Diamond Bar Minerals LLC
5070 Mark IV Pkwy
Fort Worth, TX 76106

RE: Response to Agency Review Comments and Request for Additional Information, Palm Park Dona Ana 2019 Minimal Impact Exploration Project, Permit No. DA004EM - Dona Ana County, New Mexico

Figure 1. Showing borehole JD-7 ALTERNATE.

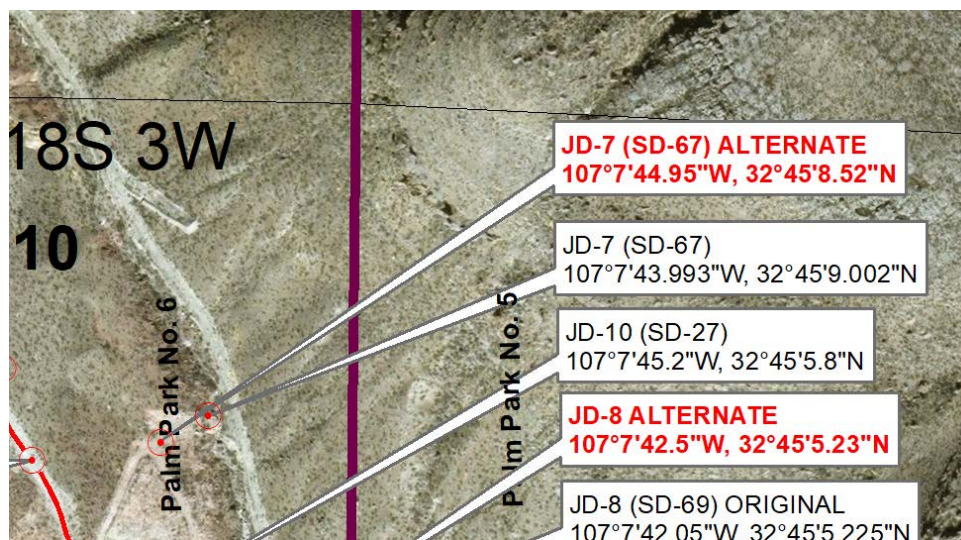
1. In response to your first item addressing issues with the location of certain boreholes and access to them, please consider the following changes.
 - A. Borehole JD-6 (relabeled JD-6 ALT) will be relocated to $32^{\circ}45'0.705''\text{N}$ & $107^{\circ}7'40.17''\text{W}$. Access to this location is provided by Road Repair 4 discussed below. Figure 4 below shows the location of JD-6 ALT and the access to it.
 - B. Borehole JD-7 (relabeled JD-7 ALT) will be relocated to $32^{\circ}45'8.52''\text{N}$ & $107^{\circ}7'44.95''\text{W}$. This alternate location is directly on the existing road with no acreage outside of existing roads to be disturbed to gain access. See Figure 1.

Figure 2. Showing borehole JD-8 ALTERNATE and access.

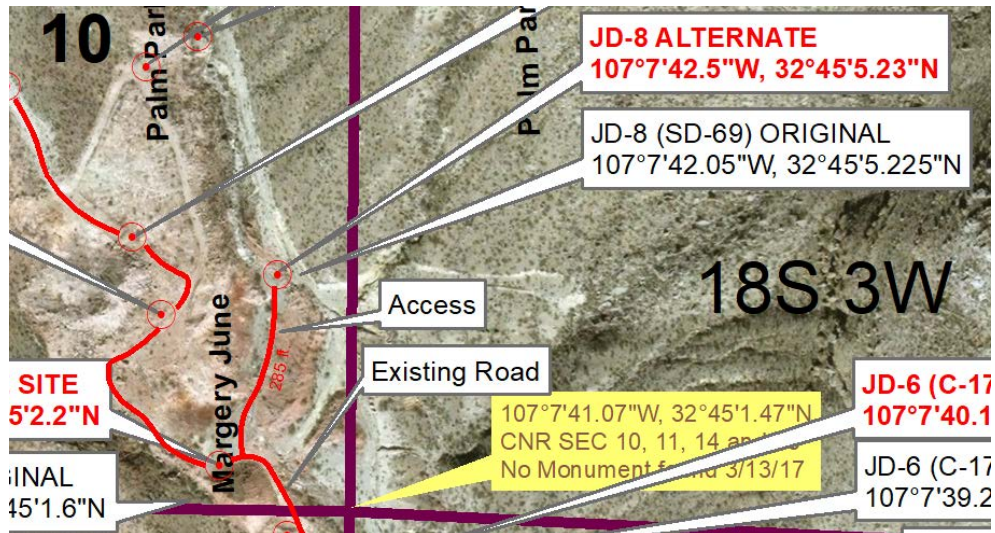
- C. Borehole JD-8 (relabeled JD-8 ALT) will be relocated to $32^{\circ} 45' 5.23''\text{N}$ & $107^{\circ} 7' 42.5''\text{W}$. To access this location it will be necessary to traverse 285 feet exiting the existing road due south of the location. Maximum area to be disturbed will be 285 ft. long x 10 ft. wide (or 2,850 sq. ft.). See Figure 2.

Figure 3. Showing borehole JD-15 ALTERNATE

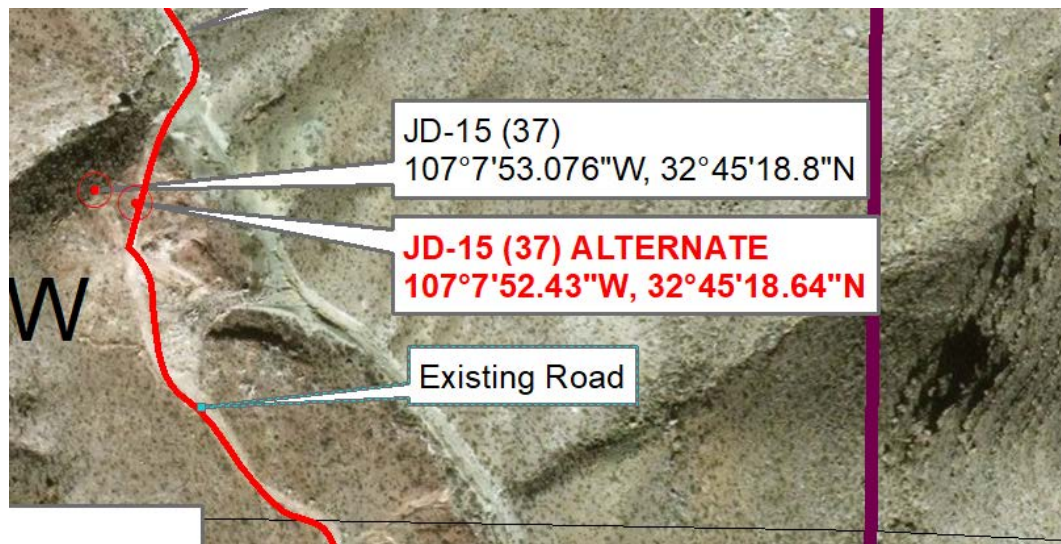
- D. Borehole JD-15 (relabeled JD-15 ALT) will be relocated to $32^{\circ} 45' 18.64''\text{N}$ & $107^{\circ} 7' 52.43''\text{W}$. This alternate location is directly on the existing road with no acreage outside of existing roads to be disturbed to gain access. See Figure 3

Figure 4. Showing borehole JD-6 Alternate and access to JD-6, JD-17 and JD-18.

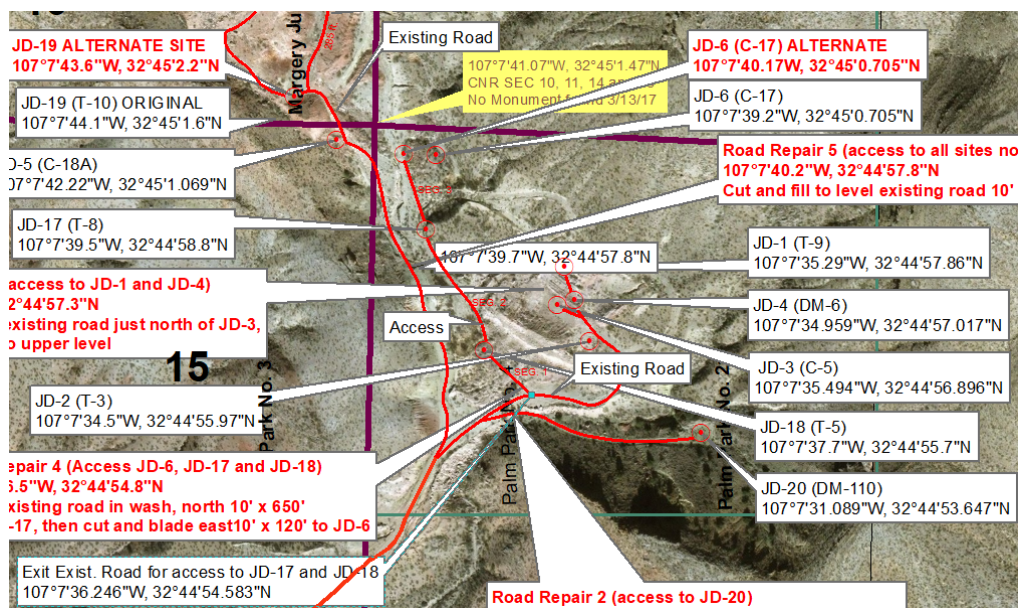
- F. The group of boreholes including JD-6 Alternate, JD-17 and JD-18 will be accessed by the route shown in Figure 4 and includes 3 different segments ("SEG #") constituting the overall access route, which totals 733 ft. The maximum area to be disturbed to access this group of boreholes will be 733 ft. long by 10 ft. wide (or 7,333 sq. ft.). Details of access to these locations are as follows:

- Segment 1 (SEG 1): Exit existing road going straight in a northwesterly direction from Lat/Long 32° 44' 54.583" N & 107° 7' 36.246" W clearing to a maximum width of 10 feet, a distance of 183 feet to borehole JD18. Maximum area to be disturbed will be 183 ft. long x 10 ft. wide (or 1,830 sq. ft.).

- Segment 2 (SEG 2): Starting at borehole JD18 continue clearing in a northwesterly direction a maximum width of 10 feet, a distance of 350 feet to borehole JD-17. Maximum area to be disturbed will be 350 ft. long x 10 ft. wide (or 3,500 sq. ft.).

- Segment 3 (SEG 3): Starting at borehole JD-17 continue clearing in a northwesterly direction a maximum width of 10 feet, a distance of 200 feet to borehole JD-6 Alternate. Maximum area to be disturbed will be 200 ft. long x 10 ft. wide (or 2,000 sq. ft.).

Figure 5. Showing access to borehole JD-20.

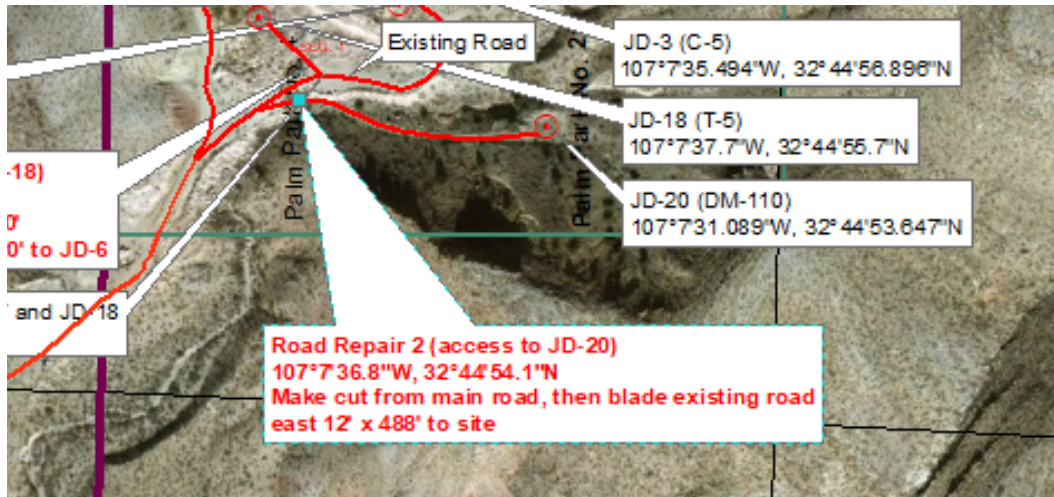
- G. The map submitted with the original application mistakenly showed both a Borehole JD-20 (which has been removed from the current map) and a Borehole JD-20 ALT which has been relabeled as Borehole JD-20. Borehole JD-20 can be accessed via an existing (but unmaintained) road, provided a cut is made at intersection of existing main road (Lat/Long 32° 44' 54.1" N & 107° 7' 36.8" W) to re-establish connection to the unmaintained road, as shown on Figure 5. We plan to clear the existing road to a maximum width of 10 feet x 488 ft. (or 4,880 sq. ft.) to borehole JD-20. See Figure 5.

PALM PARK CLAIM GROUP
Drill Hole and Access Road Display
Dona Ana County, New Mexico

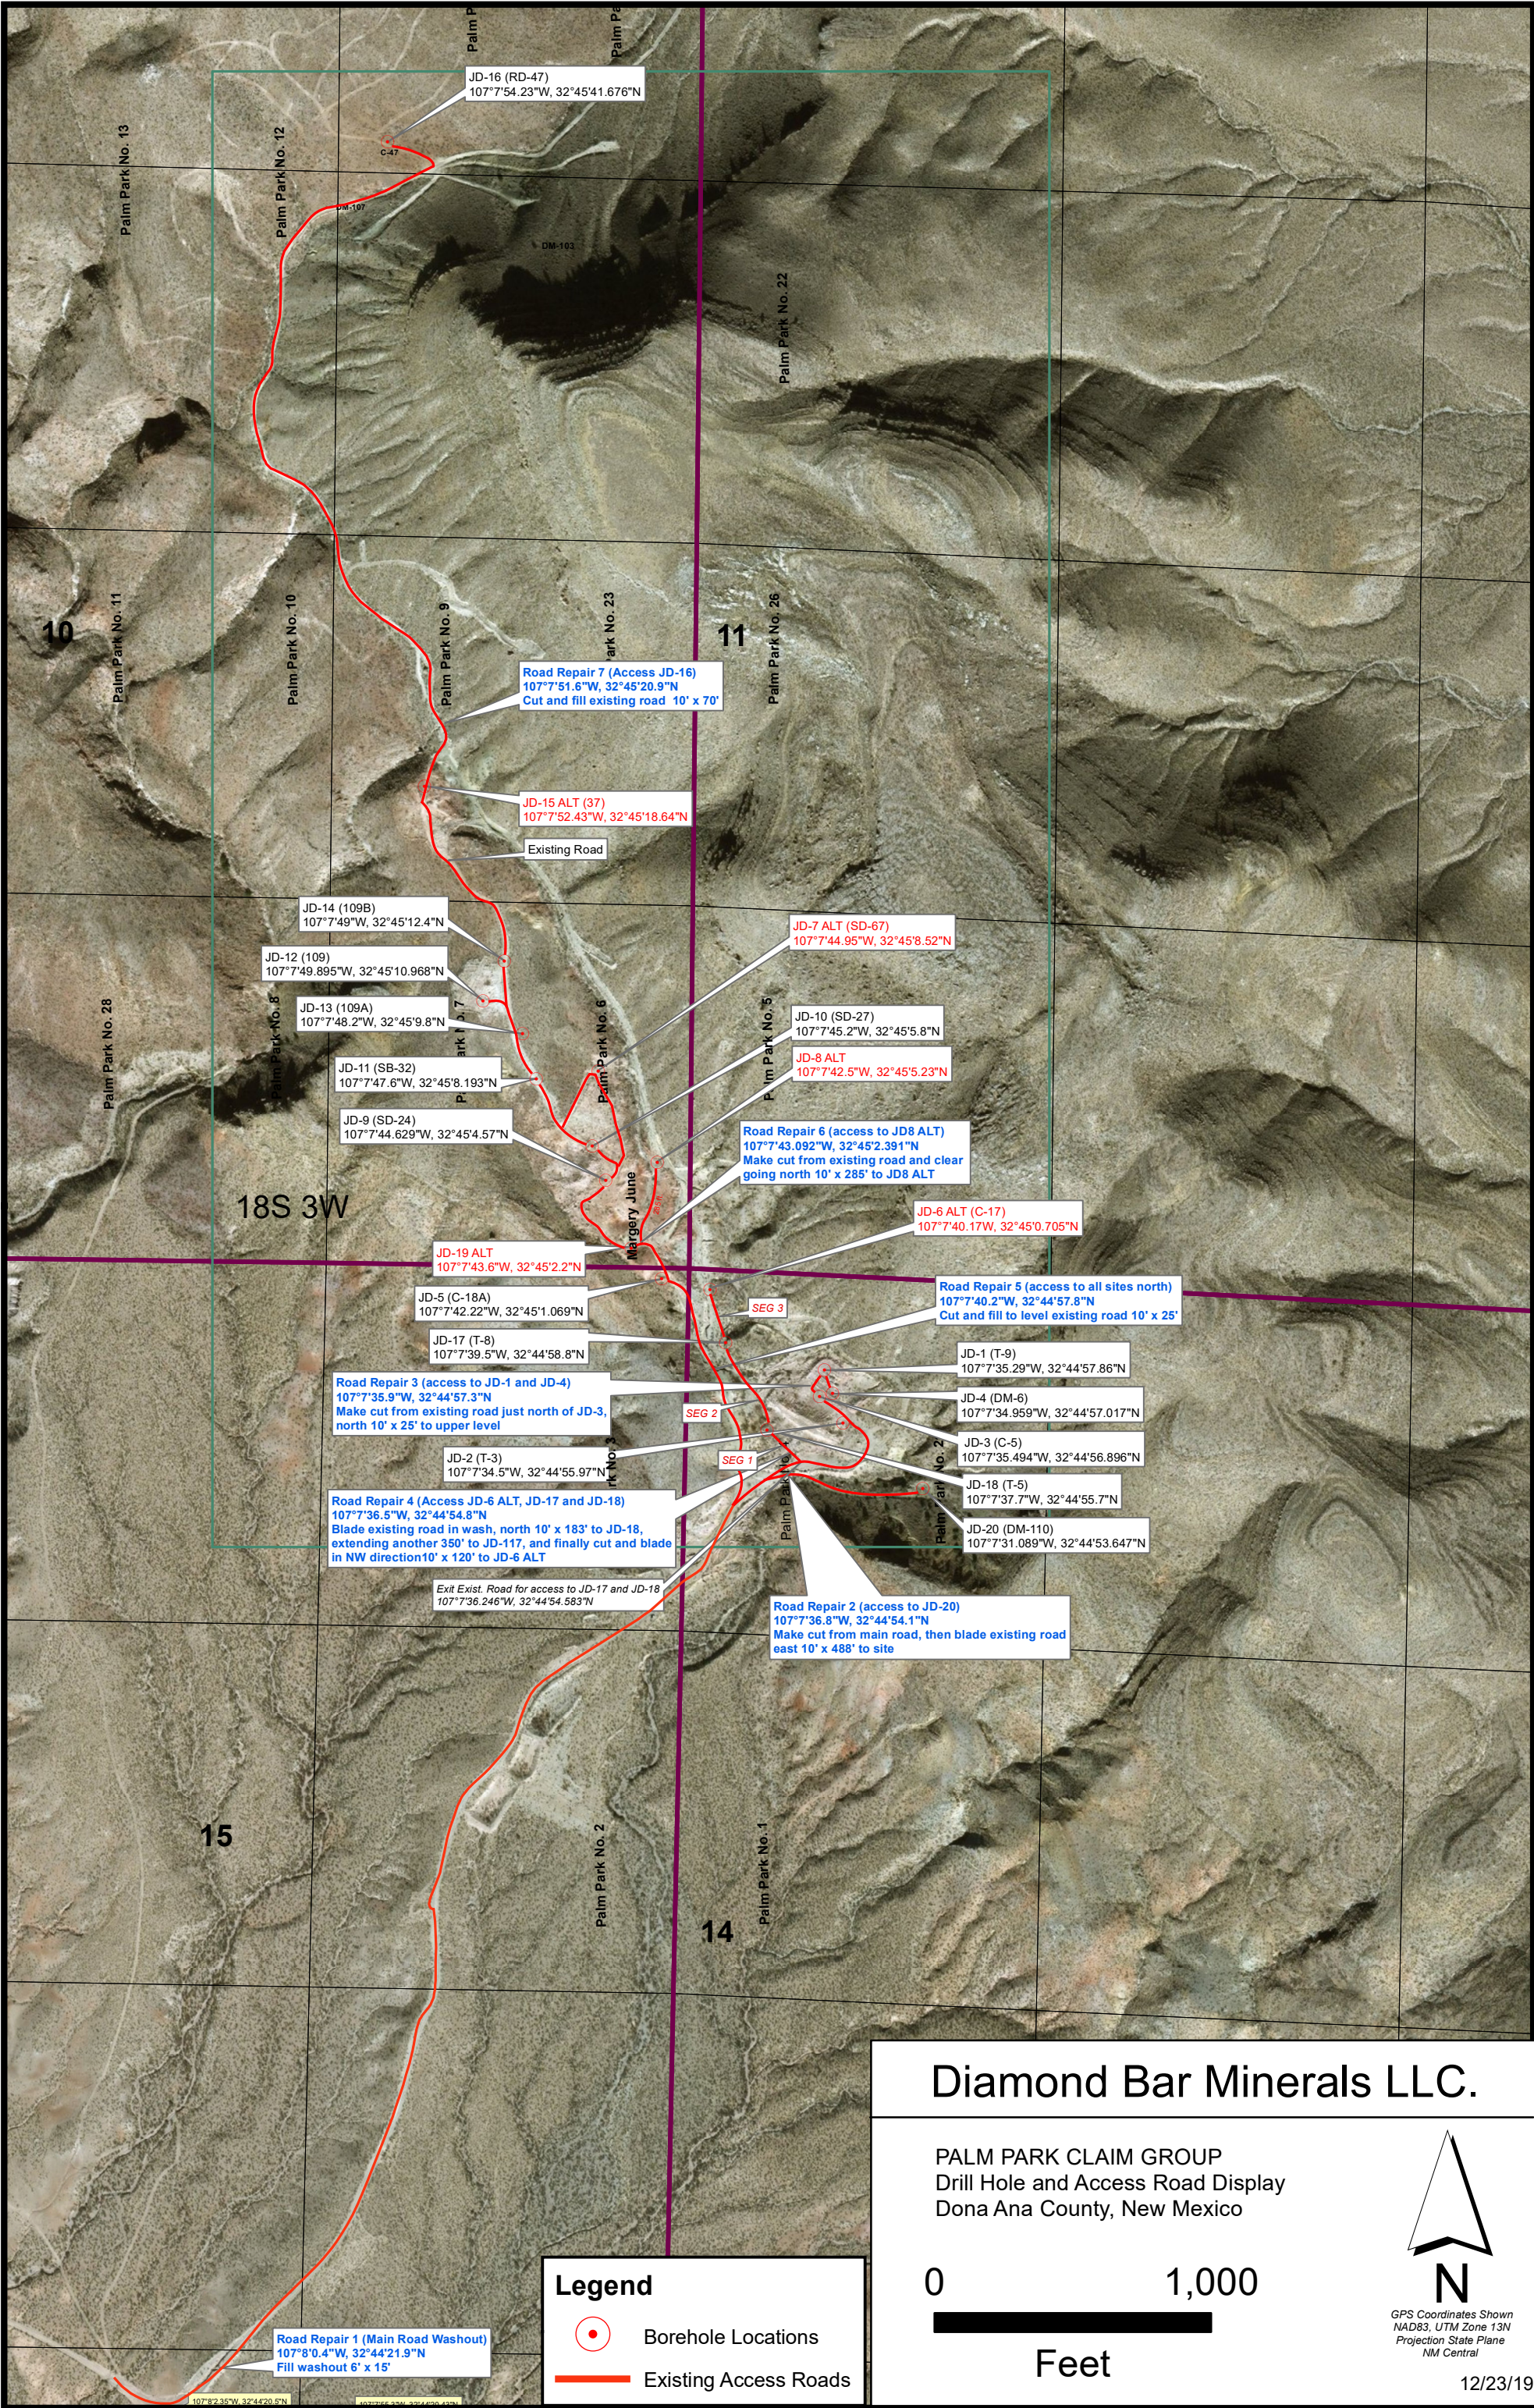
- H. The following list summarizes the required road repairs which are shown on the attached aerial map.
1. Main road washout, 6'x15' (90 sq. ft.).
 2. Access to JD-20, 10'x488' (4,880).
 3. Access to JD-1 & JD-4, 10'x25' (250 sq. ft.).
 4. Access to JD-6 ALT, JD-17 & JD-18, 10'x733' (7,330 sq. ft.).
 5. Access to all sites north, 10'x25' (250 sq. ft.).
 6. Access to JD-8 ALT, 10'x285' (2,850 sq. ft.).
 7. Access to JD-16, 10'x70' (700 sq. ft.).

2. The typo for borehole JD-2 has been corrected. A revised Section 3, Page 7 of the application is attached with the revised GPS coordinates of each site.
